Kentucky Transportation Cabinet Value Engineering Study Mountain Parkway Corridor – Construction Sequence 1

Final Value Engineering Study Report

Study Dates: May 12-16, 2014

November 14, 2014

VALUE ENGINEERING PROPOSAL DS-02

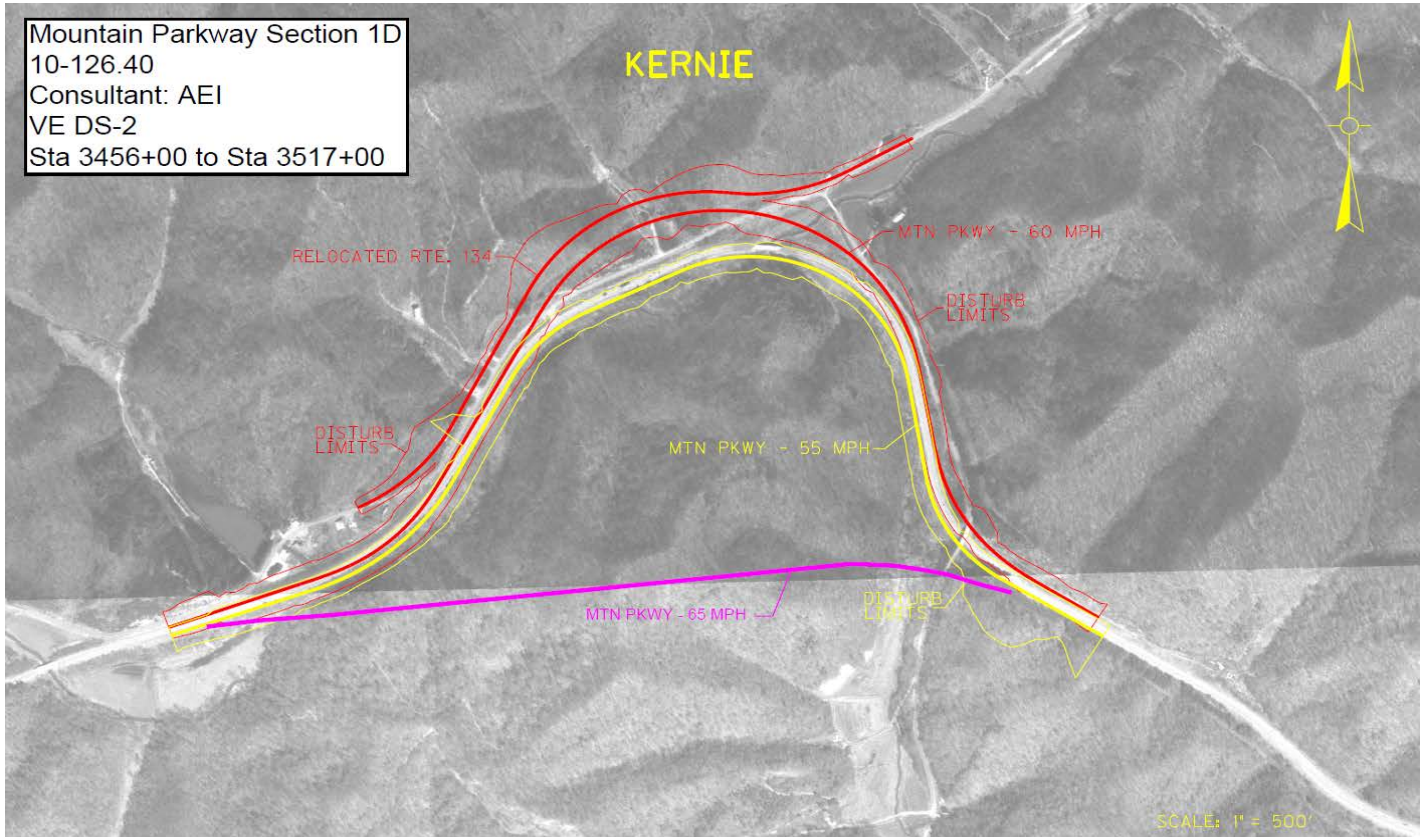
TITLE: Change design speed from 65 mph to 55 mph to reduce earthwork

PROJECT	CONSULTANT	ITEM NO.	STATION		LENGTH	EXCAVATION (MILLION CY)				
						PROJECT		SECTION		
						65 MPH		55 MPH		
			BEGIN	END	MILE	CURRENT	CURRENT	REVISED	SAVINGS (millions)	
1A	LOCHNER	10-126.70				0.85				N/A
1B	HMB	10-126.60				2.50				N/A
1C	EA	10-126.50				2.41				
			3248+00	3287+00	0.7		1.78	0.36		1.42
1D	AEI	10-126.40				8.23				
			3456+00	3517+00	1.2		4.73	0.39		4.34
			3527+00	3551+00	0.5		0.28	0.09		0.19
			3590+00	3603+00	0.2		0.39	0.15		0.24
1E	MEC	10-167.00				1.53				
			3603+00	3634+00	0.6		1.00	0.32		0.68
1F	PB	10-126.12				3.70				
			3705+00	3784+00	1.5		1.92	0.75		1.17
1G	VM	10-140.00				1.34				
			3848+00	3891+00	0.8		0.43	0.20		0.23
						5.5	20.56	10.53	2.26	8.27
TOTAL DIFFERENCE										8.27
TOTAL CONSTRUCTION SEQUENCE 1						20.56				12.29
